**ARM ETM
ETB11 (TM070)
Errata Notice**

This document contains all errata known at the date of issue in releases up to and including revision r0p1 of Embedded Trace Buffer for ETM11 (ETB11)

311060: Scan Enable incorrectly factored into ETB11 Trace RAM Write Enable

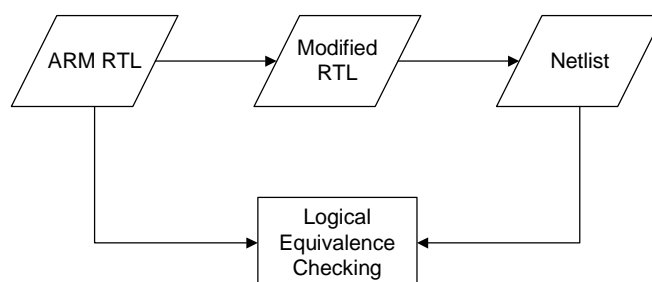
When the SE (Scan Enable) input to ETB11 is high, the Write Enable to the ETB11 Trace RAM is always active.

This can result in random data being written into the RAM and means that the RAM interface cannot be fully tested with full-sequential ATPG patterns.

Investigation using TetraMAX (version 2002.05-3) to generate full-sequential stuck-at ATPG patterns shows the difference in fault coverage with the Write Enable (WE) to the RAM forced low or forced high is negligible (99.77% with WE forced high and 99.69% with WE forced low).

The WE term in Etb11SRAMIntf.v (line 153) can be changed to:

```
assign WE = WEbus & {4{~SE}};
```

This forces WE inactive when SE is high. This modification does affect the functional operation of ETB11.

403350: ETB RAM location 0x0 might be corrupted when using the ETB RAM as system memory

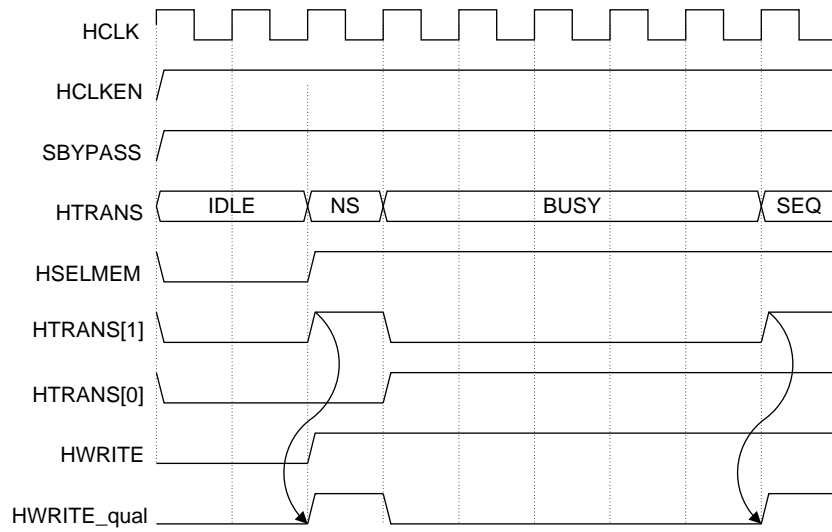
The AMBA AHB specifications allow a master to insert BUSY cycles during a burst transfer. An attempt to write to the ETB11 via AHB while HTRANS is set to BUSY for at least 5 cycles will corrupt location 0x0 in the ETB11 RAM.

- SBYPASS set
- A burst transfer of at least two items with 5 BUSY cycles between items
- HWRITE set for the entirety of the burst transfer
- HSELMEM set for the entirety of the burst transfer

The AHB master driving the ETB11 might assume that the IDLE transaction will always result in a zero wait-state response. This erratum might cause the AHB master to drive a new non-IDLE transaction on the AHB interface while HREADYMEM is low and therefore causing the ETB11 to miss the new transaction.

The non-IDLE transaction might have incorrect data returned in the case of a read transaction, or a write transaction might be performed incorrectly in the ETB11.

The HWRITE signal must be qualified by HTRANS[1] before being connected to the ETB11.

```
assign HWRITE_qual = HWRITE & HTRANS[1]
```

424163: ETB11 AHB interface might respond incorrectly to IDLE transactions**Status**

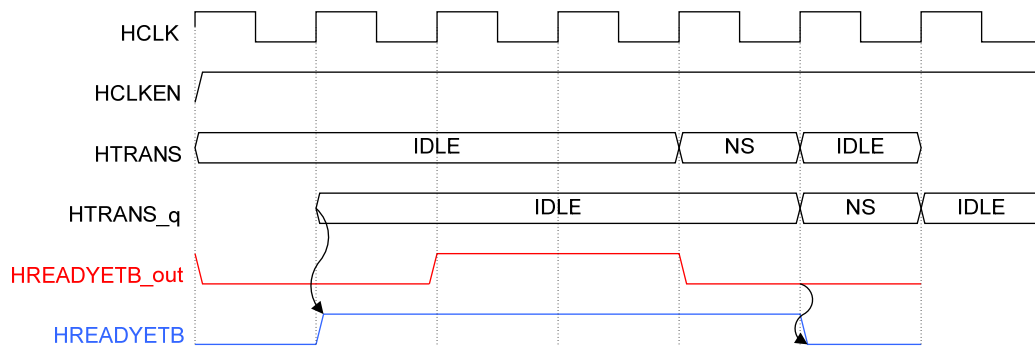
The AMBA AHB specification requires that a slave must respond to an IDLE transaction with a zero wait-state OK response. The ETB11 might not always respond with a zero wait-state OK response to IDLE transactions.

The HREADYMEM output from the ETB11 will unexpectedly be driven low during the data phase of the IDLE transaction, dependent on a certain internal state of the ETB11.

The AHB master driving the ETB11 might assume that the IDLE transaction will always result in a zero wait-state response. This erratum might cause the AHB master to drive a new non-IDLE transaction on the AHB interface while HREADYMEM is low and therefore causing the ETB11 to miss the new transaction.

The non-IDLE transaction might have incorrect data returned in the case of a read transaction, or a write transaction might be performed incorrectly in the ETB11.

The HREADYETB output from the ETB11 must be qualified based on whether an IDLE transaction is in progress. It is important that this is done during the data phase of the transfer (second cycle) and therefore a registered version of HTRANS should be used. While this registered version of HTRANS is b00 HREADYETB must be high.

This can be achieved with the following logic applied to HREADYETB output from the ETB11 creating a new HREADY output.
